# INNER WEST

## DEVELOPMENT ASSESSMENT REPORT

<b>Application No.</b>	MOD/2020/0025
<b>Address</b>	88 Liverpool Road, Summer Hill
<b>Proposal</b>	Modification of approved mixed use building for an additional apartment.
<b>Date of Lodgement</b>	5 February 2020
<b>Applicant</b>	Wil Nino
<b>Owner</b>	MMNG Holdings Pty Ltd
<b>Number of Submissions</b>	One
<b>Value of works</b>	\$1,480,500
<b>Reason for determination at Planning Panel</b>	SEPP 65 affected building
<b>Main Issues</b>	Height of building Floor space ratio Car parking
<b>Recommendation</b>	Refusal
<b>Attachment A</b>	Draft Conditions
<b>Attachment B</b>	Plans of proposed development
<b>Attachment C</b>	Applicants Assessment Against Objectives

**Figure 4:** Eastern (side) elevation showing the additional floor.

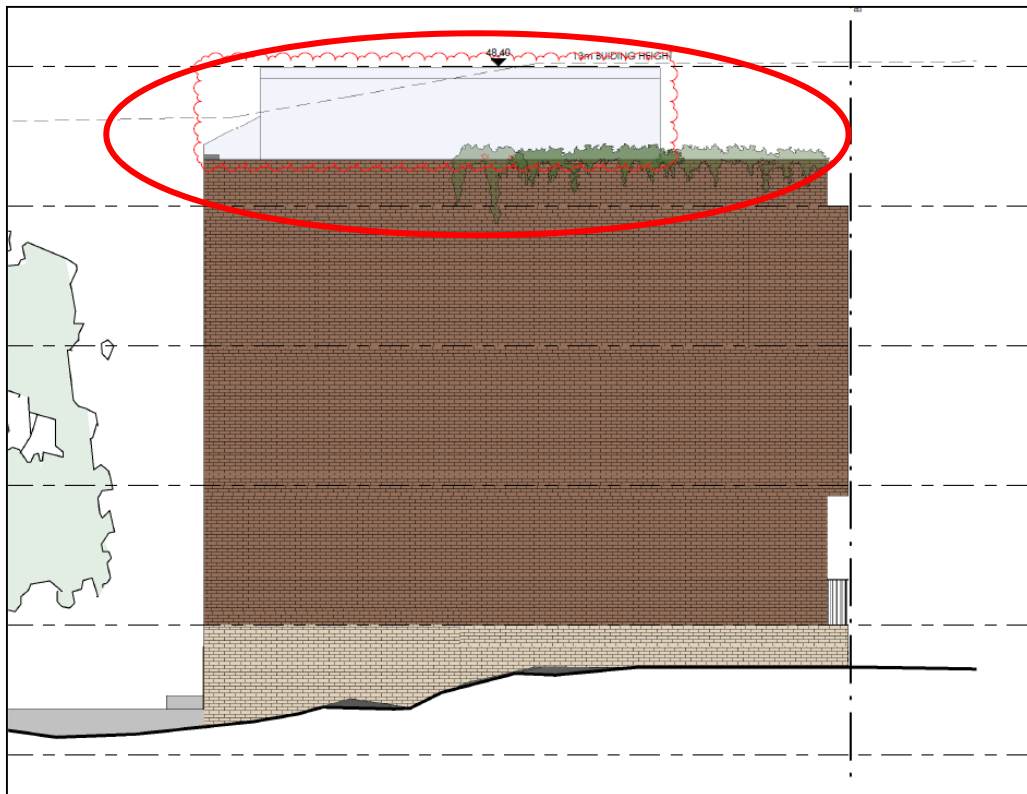
- The proposal includes within a new habitable upper level containing a 58sqm unit and private open space, resulting in a four (storey) building. The proposal results in a poorer transition in built form to the existing two (2) storey residential flat building to the east at No. 86 Liverpool Road. It also results in a poorer built form transition to the height of future development anticipated on the neighbouring sites to the east which have a 13m height control. The additional floor will be readily visible from Liverpool Road and will noticeably add to the visual bulk of the building (see Figure 4 below).

**Figure 5:** Red line showing portion of building within three (3) metres of the 13m height control.

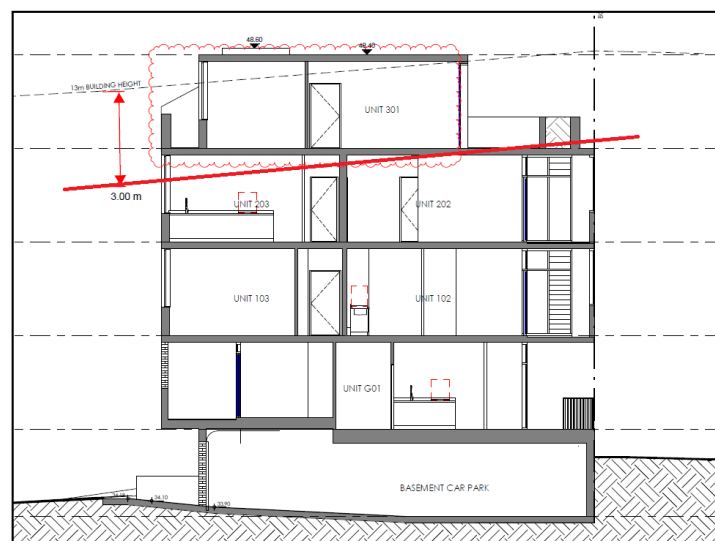
The proposal includes gross floor area within three (3) metres of the 13m height control (see Figure 5 below) and is therefore contrary to Clause 4.3(2A).

It is noted that the existing building has elements within the three (3) metres and marginally over the 13m height control which include a light-weight pergola structure relating to the rooftop communal open space, as well as a lift and stair overrun. These elements are centrally located on the roof plane and relatively small and/or lightweight, and as such are not readily visible from the public domain nor significantly add to the visual bulk or envelope of the building. They also are not considered gross floor area and thus Clause 4.3(2A) is not applicable to them.
